QUALITY ASSURANCE -- NON-CONFORMANCE REPORT

Report No: NCR-000413

NCR #: ZPMC-0387

Reference Description: Missed MT indication on South Tower, Lift 3, Diagonal Stiffener weld

项目名称 Project Name:	英坭海湾大桥 SFOBB	部件图号 Drawing No.:	SSTL3-1C/K	报告编号 Report No.:	T-CWR 253
合同号 Contract No.:	04-0120F4	部件名称 Item Name:	Tower(S) 3 rd lifting CD angle	NDT 报告编号 NDT Report No.:	T787-MT-5913
项目编号 Project No.:	ZP06-787

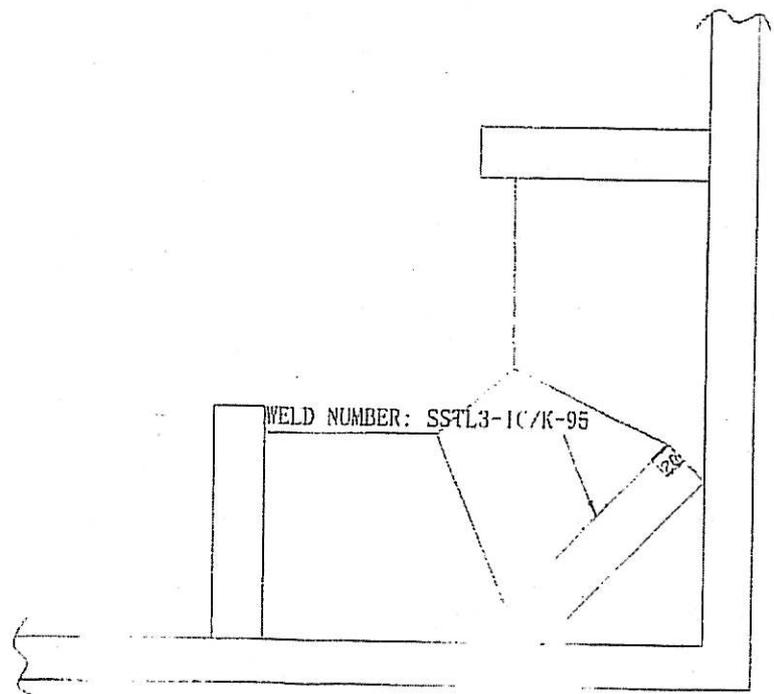
焊缝缺陷描述:
 Description of Welding Discontinuity:
 在对SSTL3-1C/K-95检测时, 发现1处线性缺陷。

One line indication was found by use of MT on SSTL3-1C/K-95.

1. QC shall monitor and direct the welder and the grinder doing the repair operation.
2. Preheat before gouging; the temperature shall be at least 65°C.
3. Gouge the weld to remove identified defects.
4. Joint details shall refer to the approved WPS repair.
5. Grind the gouged areas to a smooth and shiny surface.
6. Verify with VT and MT to ensure no defects remain in the weld joint prior to welding.
7. QC shall monitor all welding passes being deposited.
8. QC shall ensure all slag has been removed prior the deposition of next pass.
9. Preheat and maintain interpass temperature control in accordance with the WPS.
10. Blend the weld repaired areas into the adjacent weld or base metal by grinding.
11. Perform VT, MT and UT NDT inspection to the repaired areas.
